HOLIDAY INN EXPRESS BRIER CREEK SP-51-2014

Certified Action of the City of Raleigh Planning Commission

Case File / Name: SP-51-14 / Holiday Inn Express

Nature of Case: A proposed 68,176 square foot, four-story, hotel, with 106 rooming units, on a 3.98 acre parcel zoned Thoroughfare District/Conditional Use. (TD CUD)

SP-51-2014, Holiday Inn Express – Site Plan

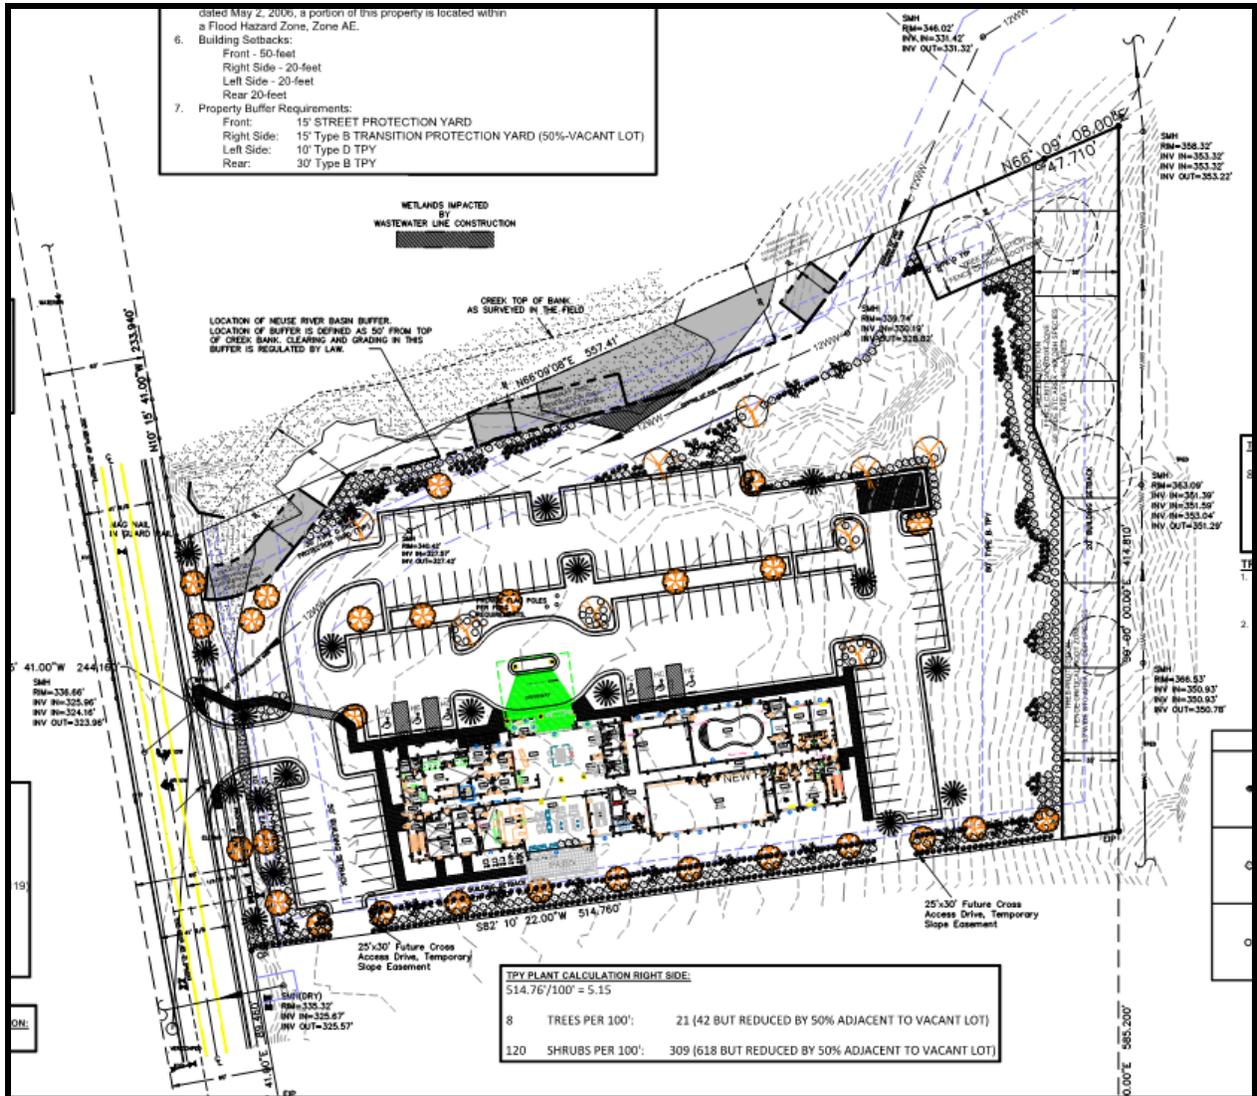
- (6) That in accordance with Part 10A Section 9.4.4, a surety equal to of the cost of clearing, grubbing and reseeding a site, shall be paid to the City;
- (7) That 7-10 parking spaces proposed on the preliminary plan in the northwest corner of the proposed parking area be relocated to the southeast corner of the proposed parking area;
- (8) That nitrogen offset payment must be made to a qualifying mitigation bank prior to approval of the site final permit. Verification of the amount of payment shall be provided to the City of Raleigh stormwater engineer.

Comment	Response
1. The Commission suggests a	A more detailed Landscape Plan will

- deliberate landscape plan for the site, including purposeful placement and a more diverse plant palette.

be completed for the Project Site.
- 2. The Commission suggests additional plantings to screen the rip rap from the roadway.

**Additional planting to screen the Rip-
rap will be provided on the Detailed
Landscape Plan.**
- 3. The Commission suggests the addition of plantings at the building base to provide pedestrian interest and visual relief for the flat expanse of the front building elevation.

**Additional planting adjacent to the
Building will be provided on the
Detailed Landscape Plan.**
- 4. The Commission suggests the use of a more durable material on the lower portion of the western elevation and northwest corner of the building and at building entrances, at a minimum. Should a cultured stone base not be feasible, the Commission suggests the use of a darker color EIFS at the building base to address both issues of maintenance and to establish a stronger visual base to the building.

**Brick will be used on the Ground
Floor of the New Building.**
- 5. The Commission suggests the addition of a plane change or break where the color palette shifts to red, to give visual interest and organization to the color shift.

**The suggested Plane change will be
added to and incorporated with the
Architectural Plans.**
- 6. The Commission commends the applicant for a thorough presentation and use of material samples.
